STATE OF IDAHO
DEPARTMENT OF WATER RESOURCES
IN-OFFICE REVIEW/BENEFICIAL USE FIELD REPORT

A. GENERAL INFORMATIONPermit No: 86-12019

PAUL & VIRGINIA CHILTON
1199 LARCH PLACE KENDRICK, IDAHO

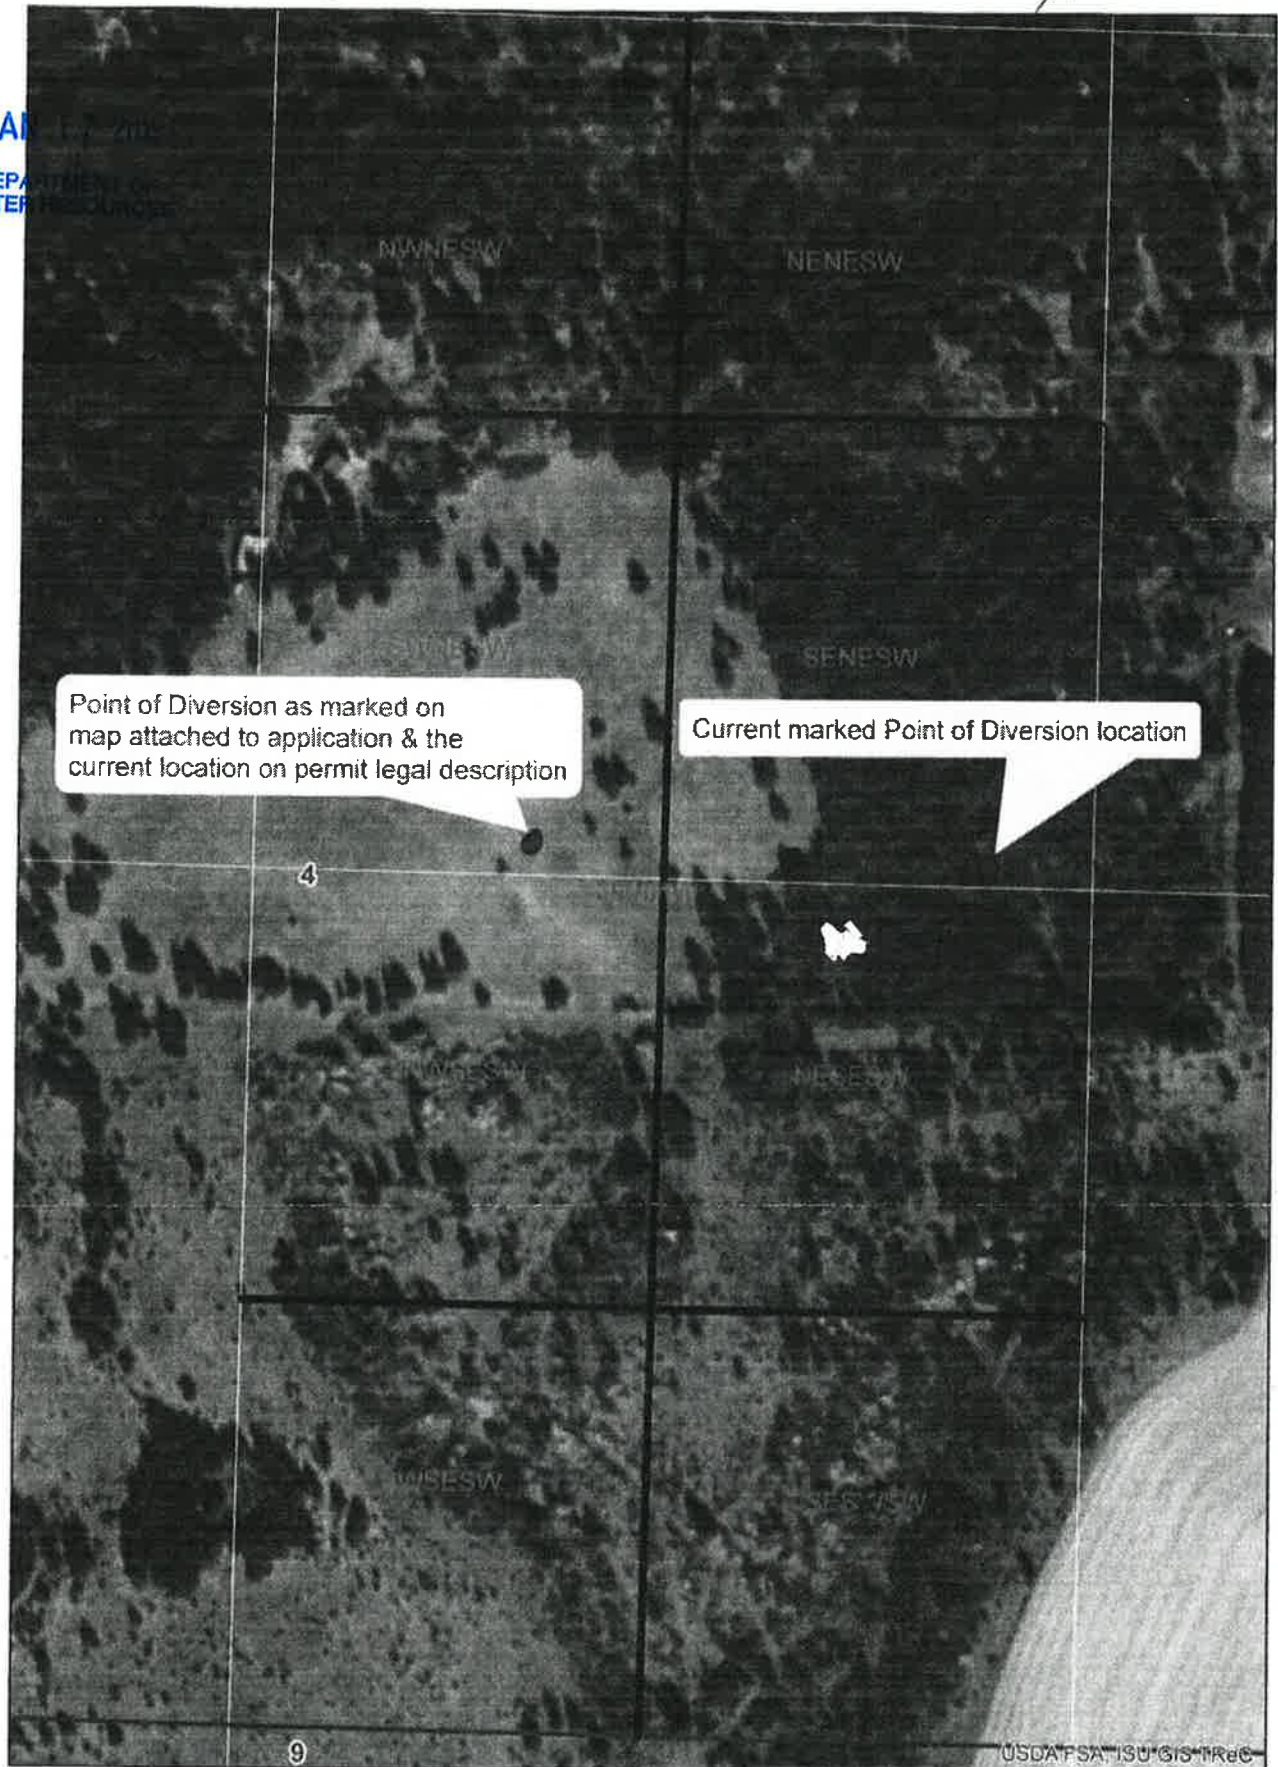
There is a question of the location of the POD. I sent Mr. Chilton a map and asked him to mark the POD. I spoke with Mr. Chilton on the phone and he said the POD is further south than the point on the map, closer to the fence line. Mr. Chilton will mail in the map with the actual POD location marked. Map from Mr. Chilton is attached.

Attached is a map with the 40 acre tract of the NESW from Latah County outlined in white. According to our GIS Dept. expert, Wilma Robertson, the taxlot information from the county is more current than our information. In ArcMap, the dot for the POD will be located in the NESESW but the legal description will be SENESW. The location on the permit for the POD is SWNESW so an amendment is needed.

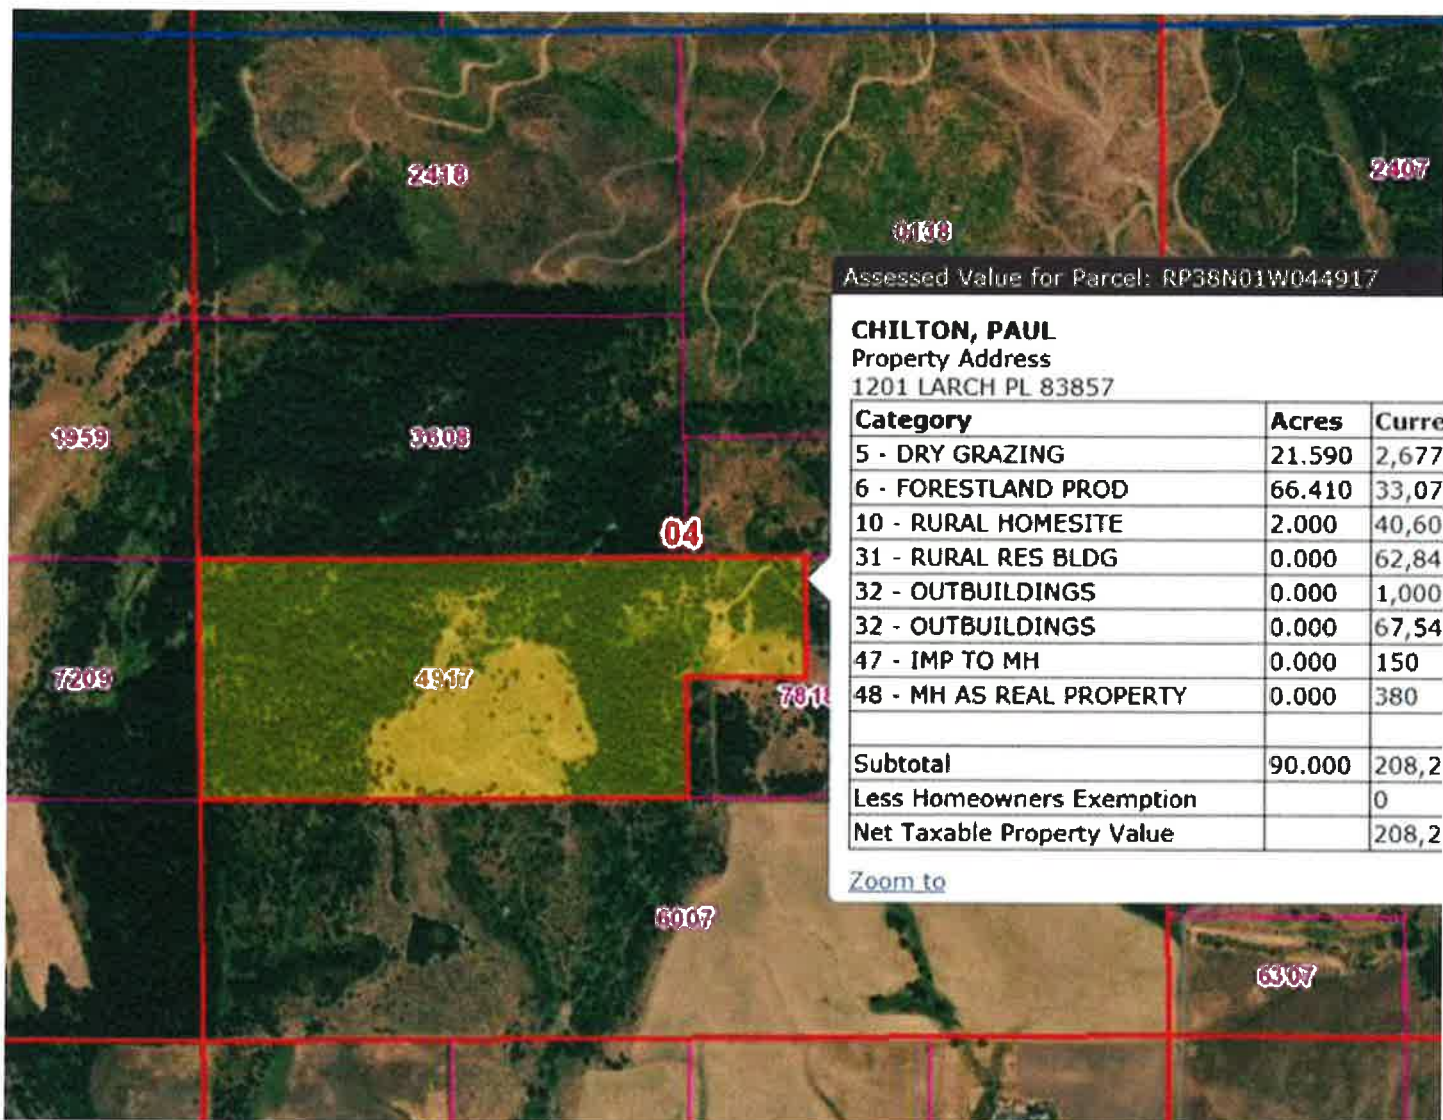
Note that both the parcel number and the shape of the parcel have changed (see the addition on the east side of the parcel in the figure above). I georeferenced a snapshot of the Latah County website onto our parcel map and confirmed that the north, west and south side of the parcel have not changed or moved relative to the aerial photo.

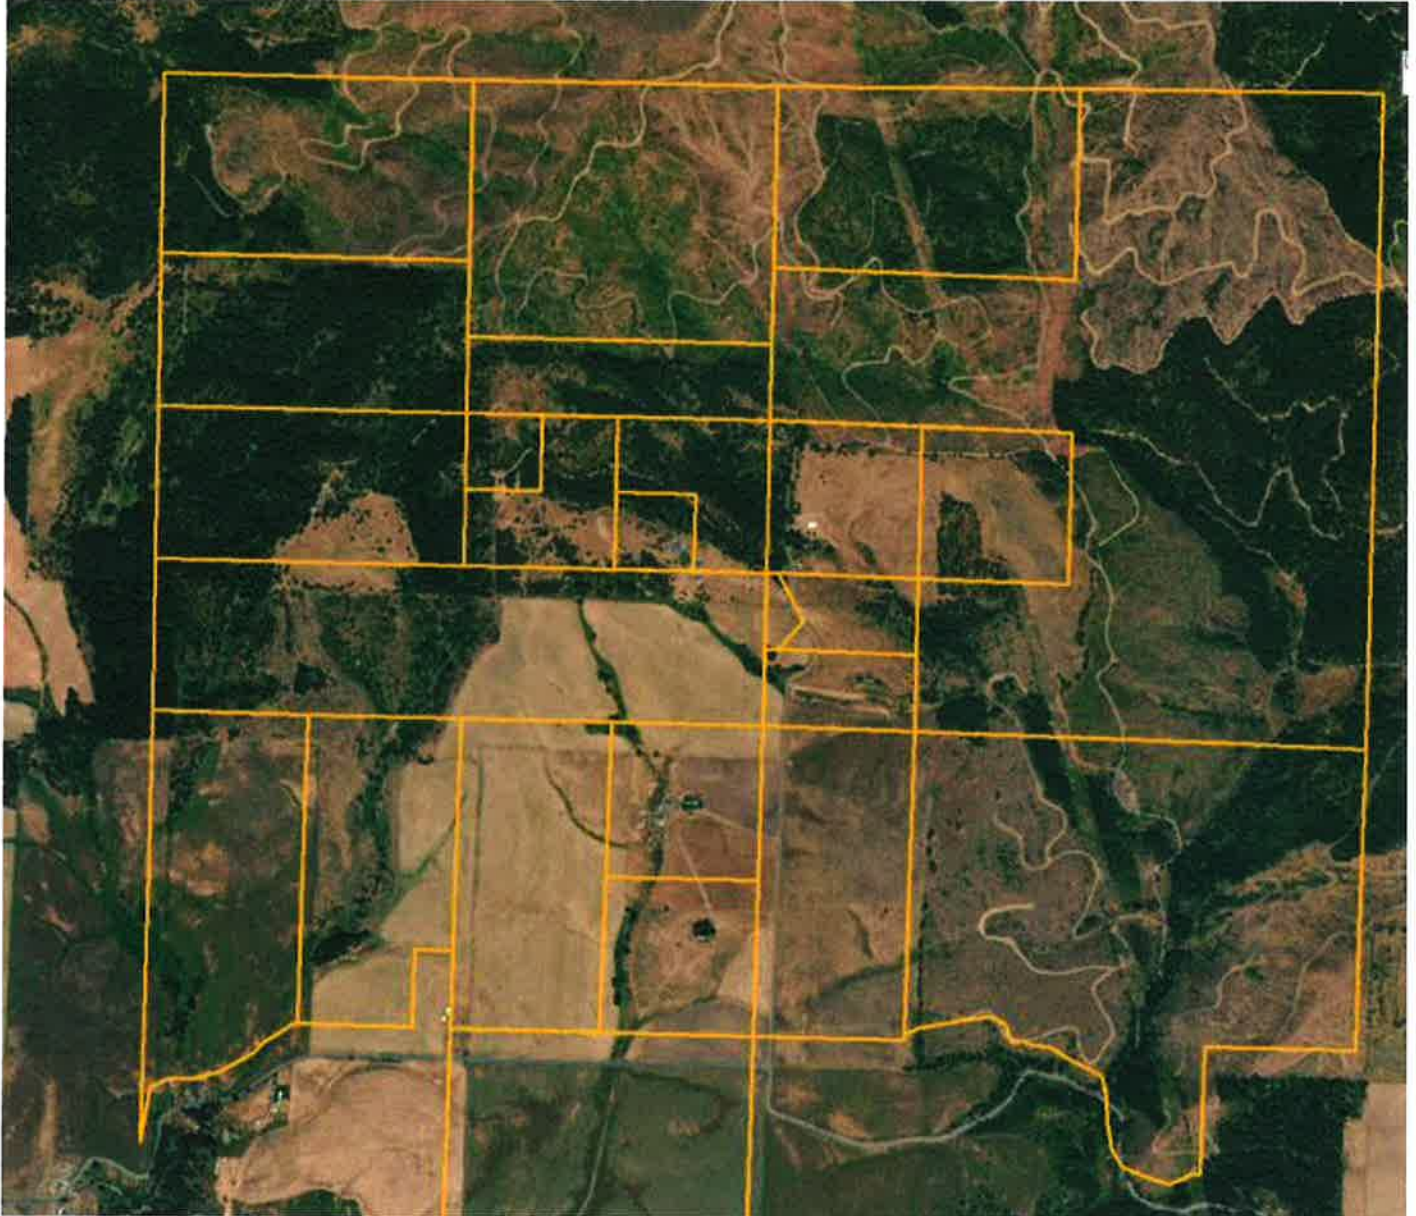
If you image what the parcels would look like if they followed our PLSS (just for *fun* I did just that – I picked up a bunch of parcels and moved them to fit our PLSS):

Needless to say that looks awful. Typically I am hesitant to judge the correct PLS based on 1 parcel and how that parcel relates to the imagery. But looking at the 15-20 parcels in the image above, I think we can be quite confident that the PLSS layer used by Latah County is correct (or at least much better) than our PLSS and we can assume that the parcel lines (the real ones, not the orange moved ones in the image above) follow the PLSS lines.
